**BEFORE
THE OHIO POWER SITING BOARD**

In the Matter of the Application of)	
Palomino Solar, LLC for a Certificate of)	Case No. 21-0041-EL-BGN
Environmental Compatibility and Public)	
Need)

**NOTICE OF RESPONSES TO DATA REQUESTS FROM THE STAFF OF THE OHIO
POWER SITING BOARD**

**PALOMINO SOLAR, LLC'S FEBRUARY 25, 2022 RESPONSES TO STAFF'S
FEBRUARY 15, 2022 WRITTEN DATA REQUESTS**

Photo 1. Likely Bald Eagle Nest.

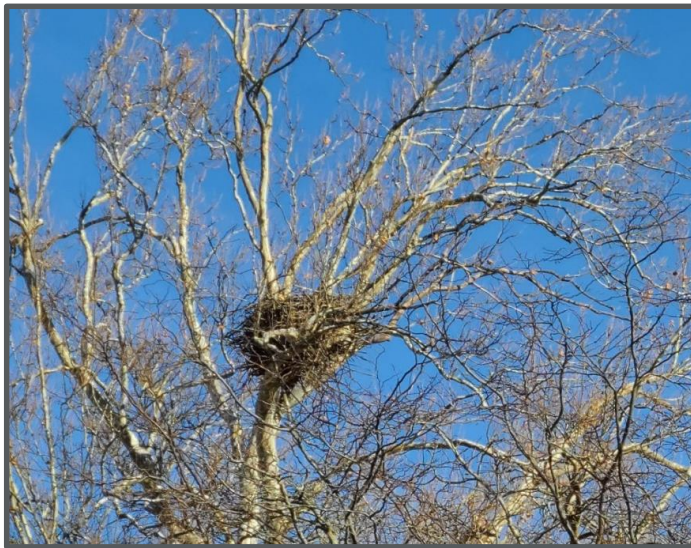
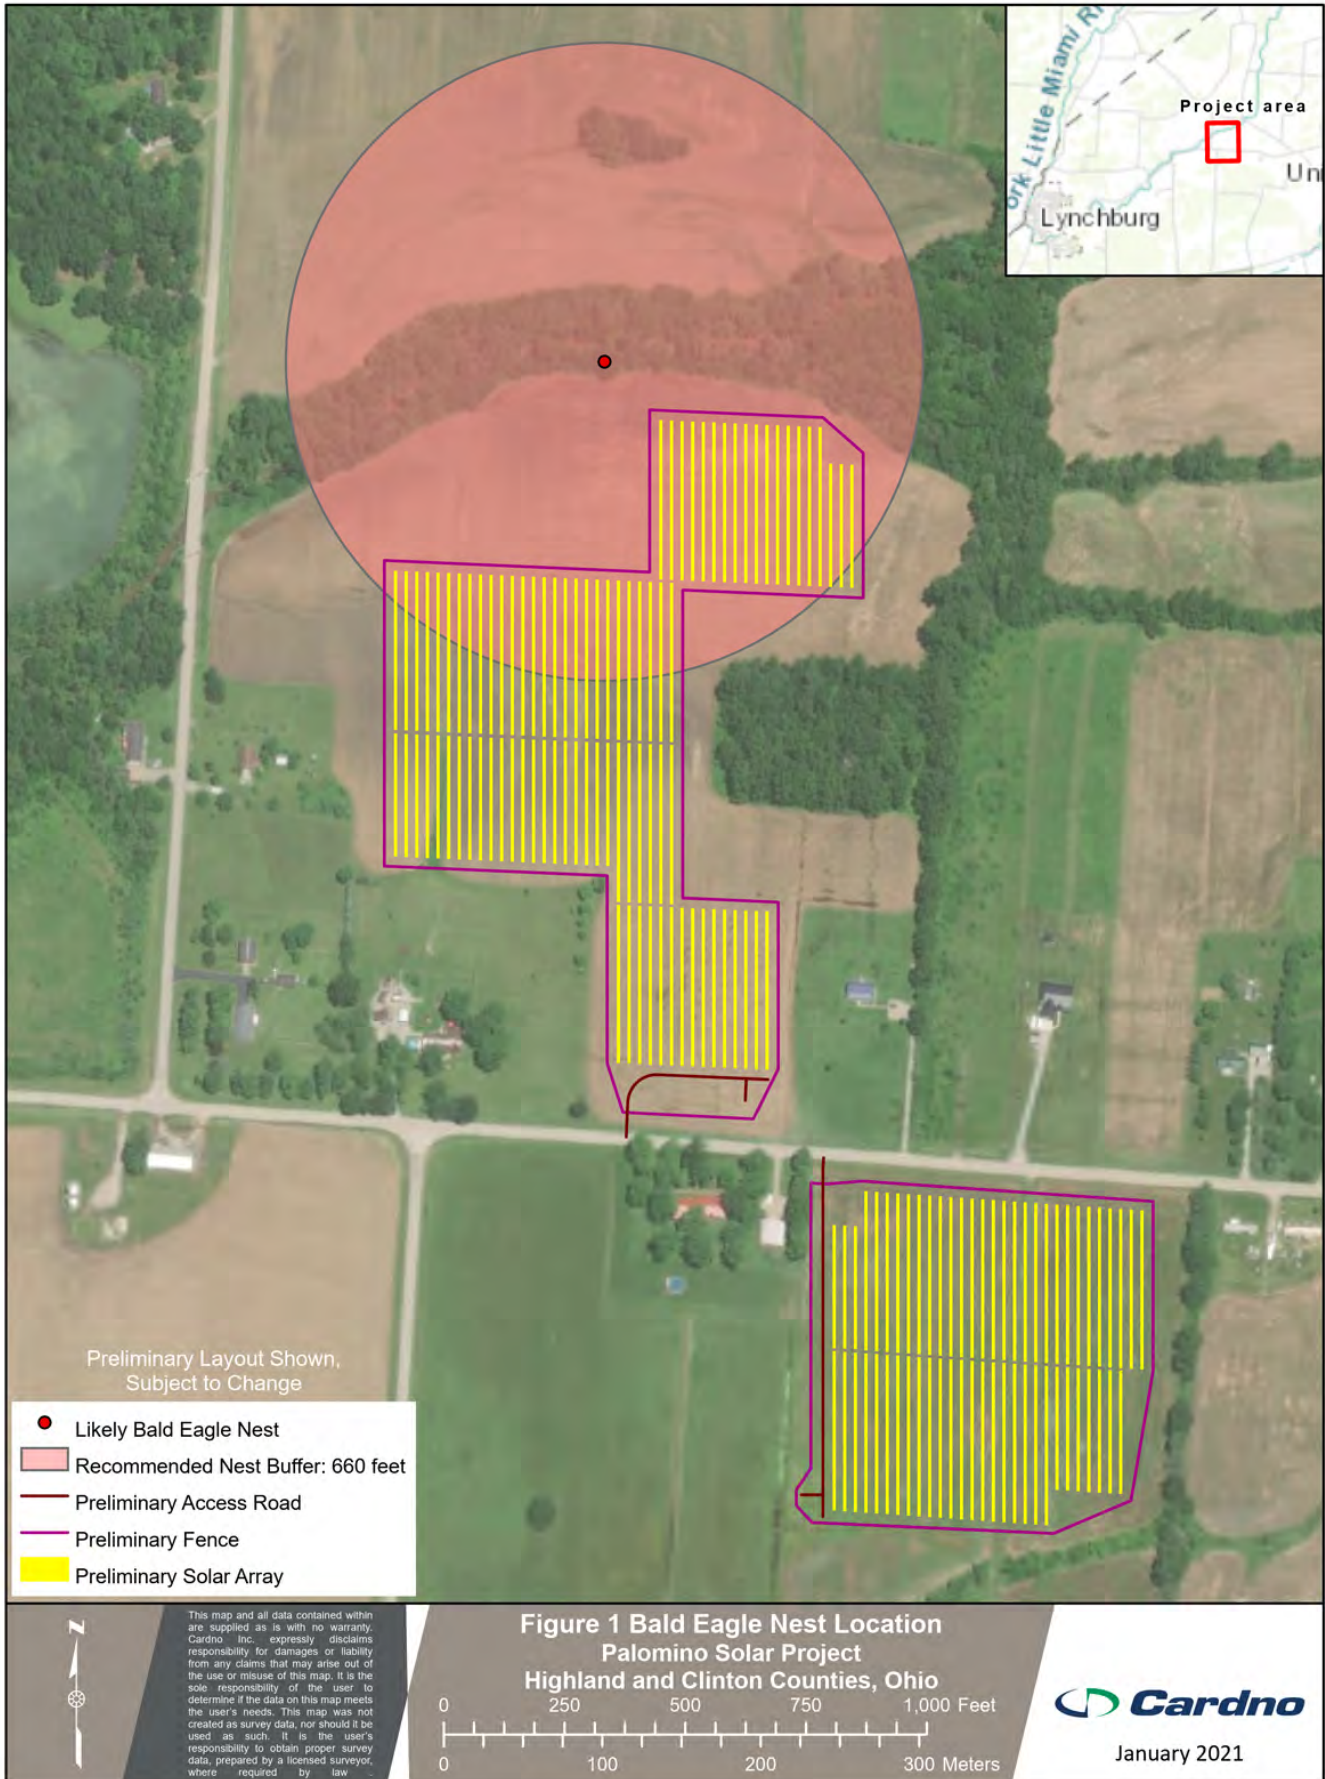
1. The USFWS identified an active bald eagle nest within 660 feet of the project area northeast of the intersection of Sharpsville Rd and Bald Knob Rd. In their coordination letter dated 10/19/2020, the USFWS recommends the area surrounding the nest be evaluated to determine if any additional eagle nests are present and to validate the actual nest location. Have you surveyed the surrounding area to determine if any additional eagle nests are present? If so, please submit your findings to Staff, if not, please explain why you have not and what your plans are to address this concern.

A letter was sent to USFWS on January 20, 2021 outlining additional fieldwork performed by Palomino Solar to identify the nest's location and observe presence of eagles. Photos of the nest and the details of proposed construction activities in the vicinity of the nest were outlined in the letter with a request for a discussion regarding the appropriate mitigation strategy to implement. USFWS replied via email with instructions for scheduling construction activities that would occur within the 660 foot seasonal buffer accordingly. Palomino Solar has since removed all components within the recommended seasonal buffer of the nest and will be abiding by the buffer year round. Thus, no additional mitigation measures are required. A copy of this correspondence is attached.

Revised Figure 08-2 Geological Features Map
Palomino Solar Energy Project
Highland County, Ohio

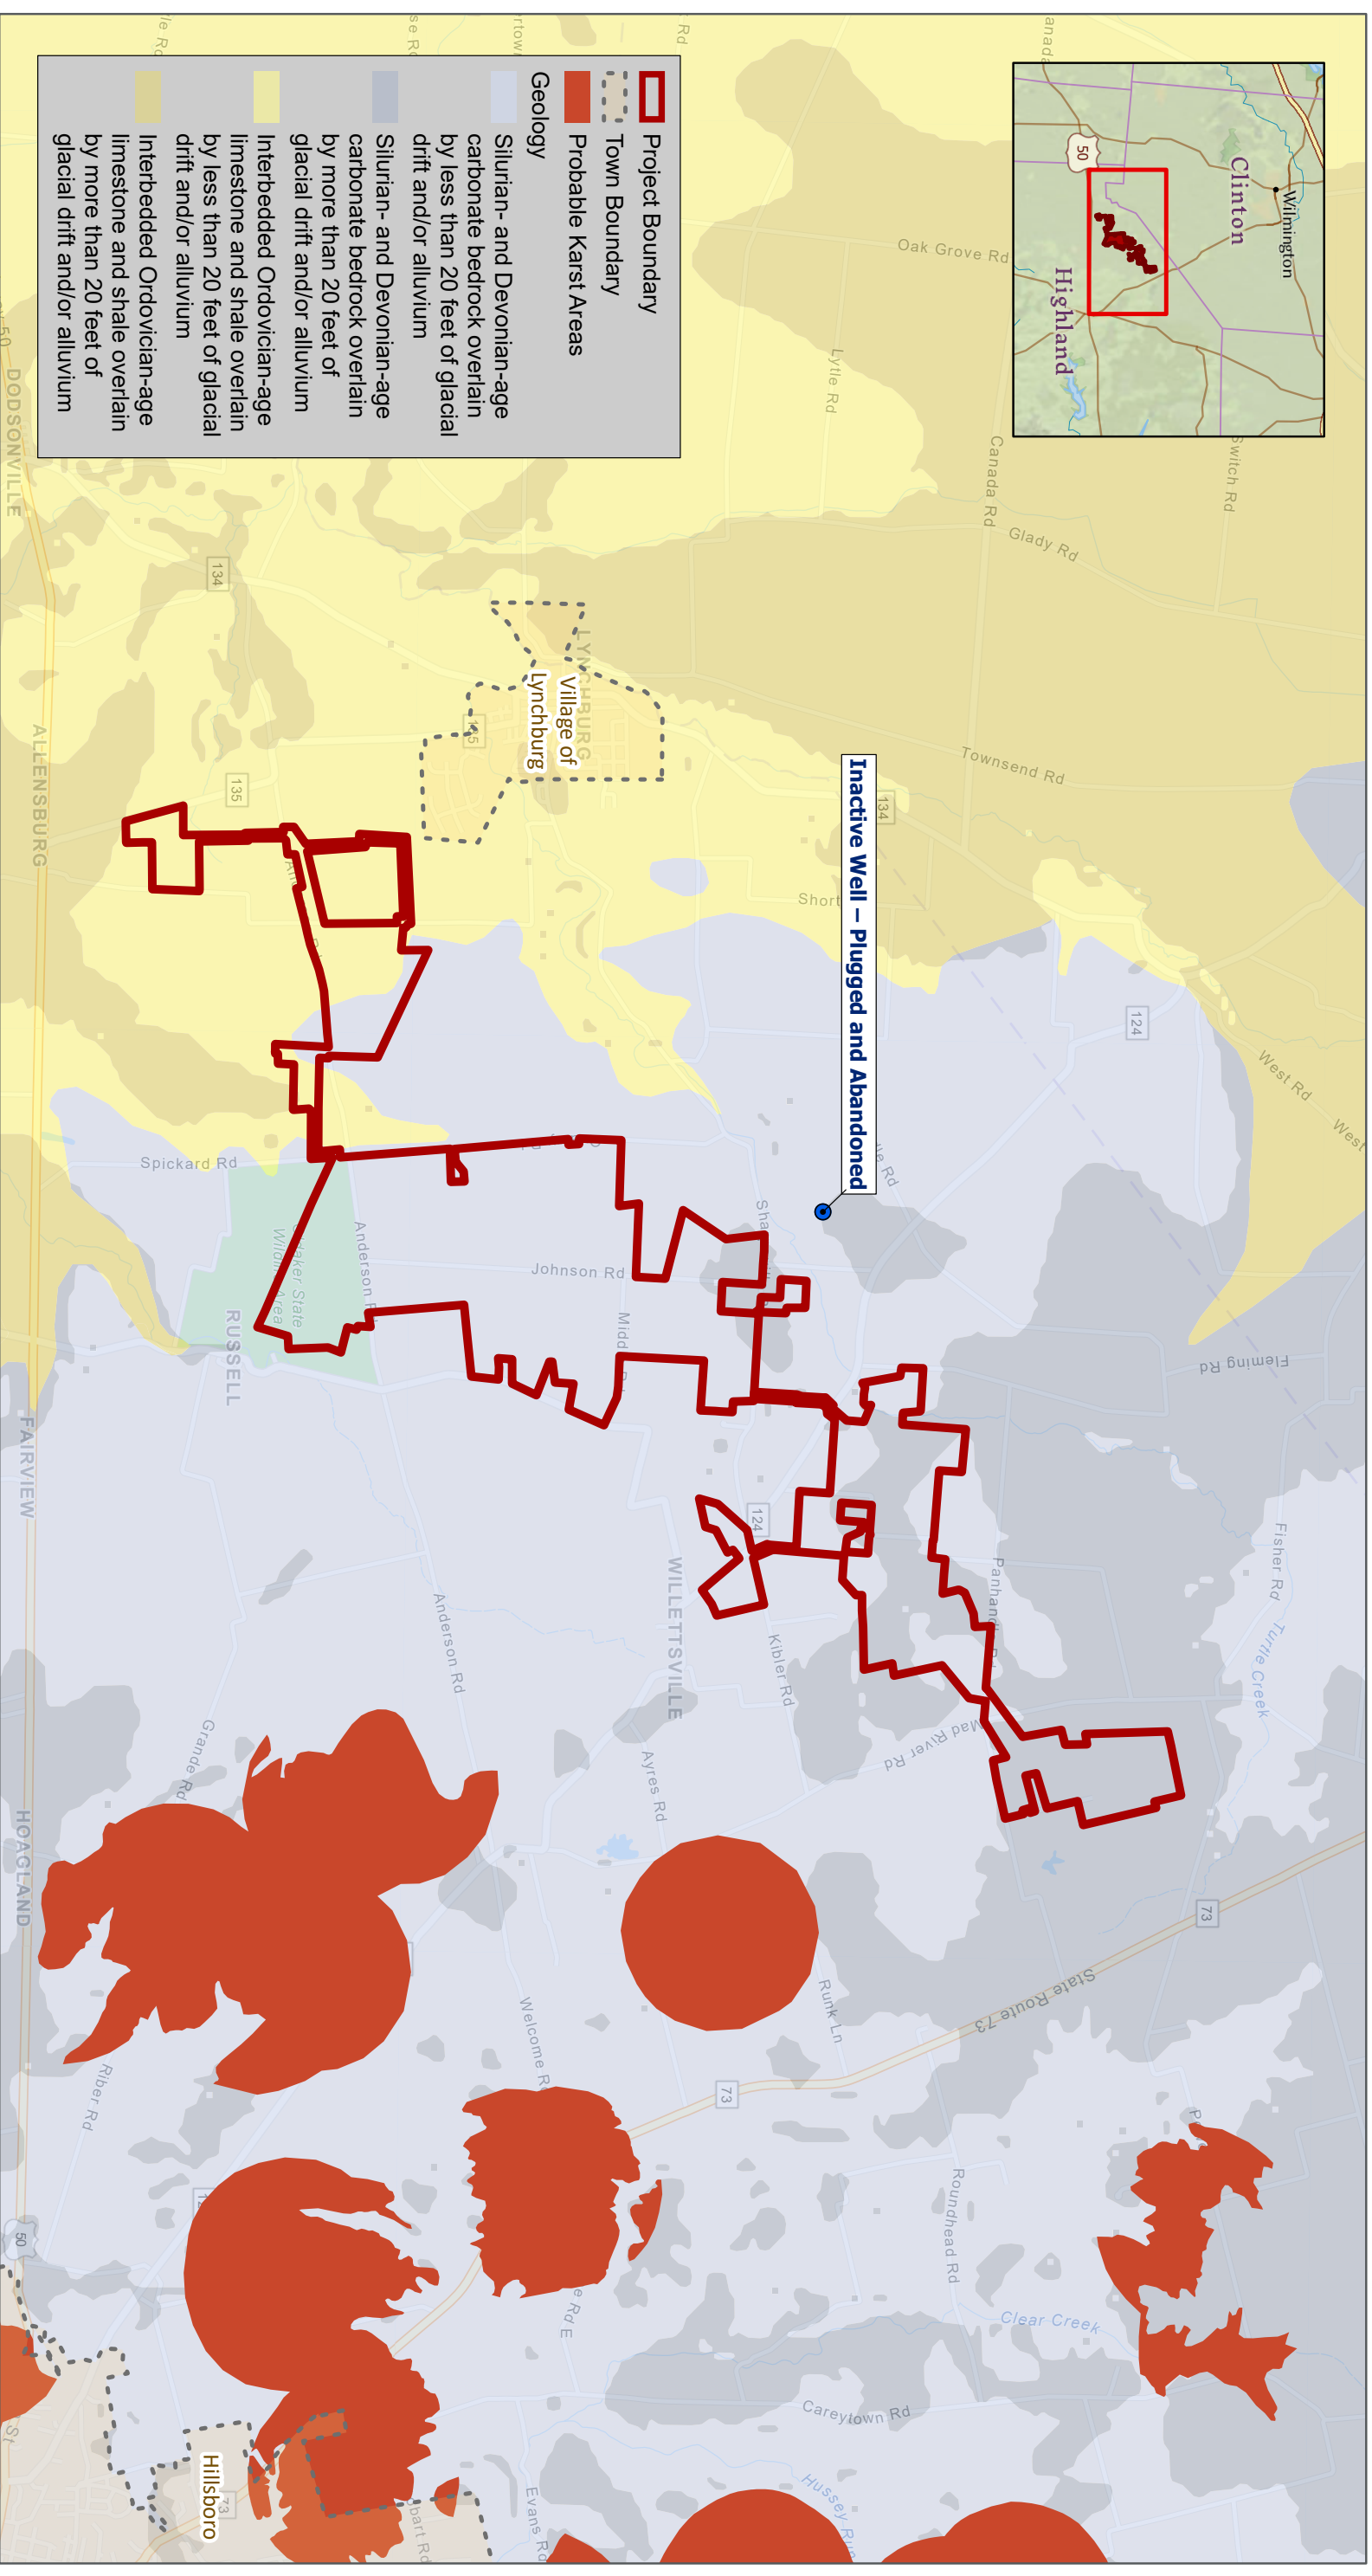
13. Please revise Figure 8-2 of the Application to include all oil and gas well features.

There are no active oil and gas wells within the Project area. There is record of one inactive oil and gas well within one mile of the Project area and Figure 8-2 has been revised to include this location. This well is identified as plugged and abandoned by ODNR Division of Oil and Gas.
